BRIDGE

BREWERY STREET

Bridge Widening on Brewery Street -  
Village of Baden, Twp. of Wilmot, Ont.  
(Bridge Office Ref. BA 1504)

Township of Wilmot,  
Culvert Extension,  
Brewer Street, Baden, Ontario,  
Bridge Office Ref. # BA 1504.

### LOCATION OF BOREHOLES

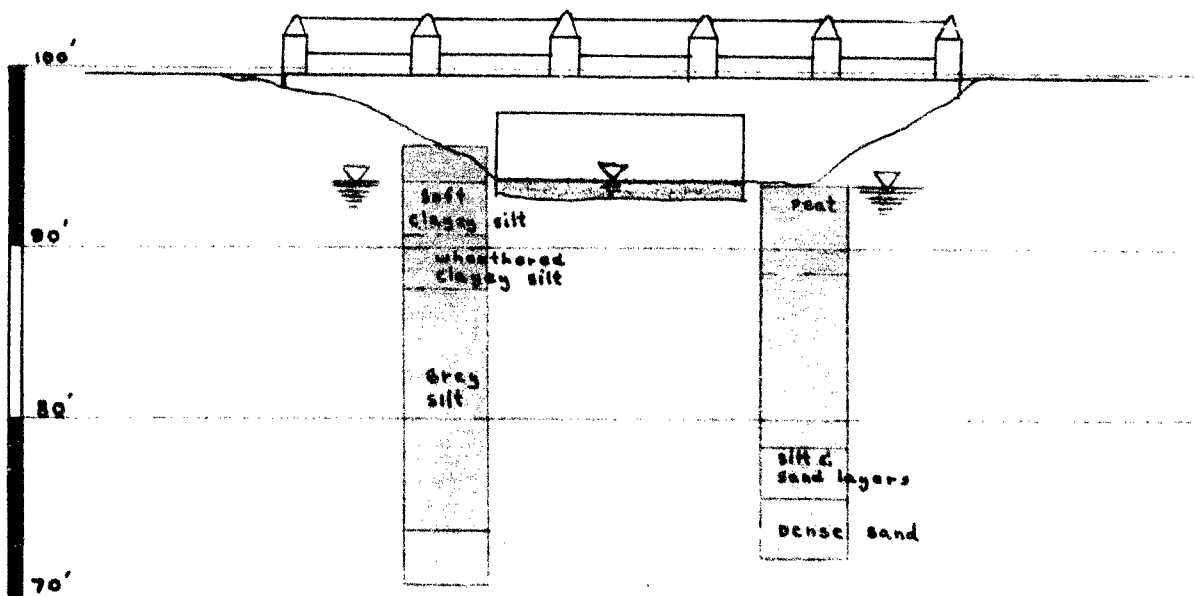
It is evident from the borehole logs that although the basic and predominant material seems to be the same (grey silt), its properties are quite different. The penetration resistances recorded in B.H. No. 1 are very low, down to approx. 20 feet below the ground surface, while in B.H. No. 2, the resistances are higher. Since the recorded resistances are the only reliable source of information on the properties for such type of soil, it has to be concluded that there is quite a difference in the material's densities.

We cannot agree with the Consultants' reasoning on the "liquefaction" of the dense silt under the influence of dynamic loading. Liquefaction could, indeed, occur but only if the silt would be very loose. In such a soil, collapse of the soil structure occurs under loading, dynamic or static, resulting in "liquefaction".

We believe, on the basis of the presented information, that the soil where Borehole No. 1 was put down, is, in fact, loose and we would therefore recommend that the allowable pressure be reduced to 1,500 p.s.f.
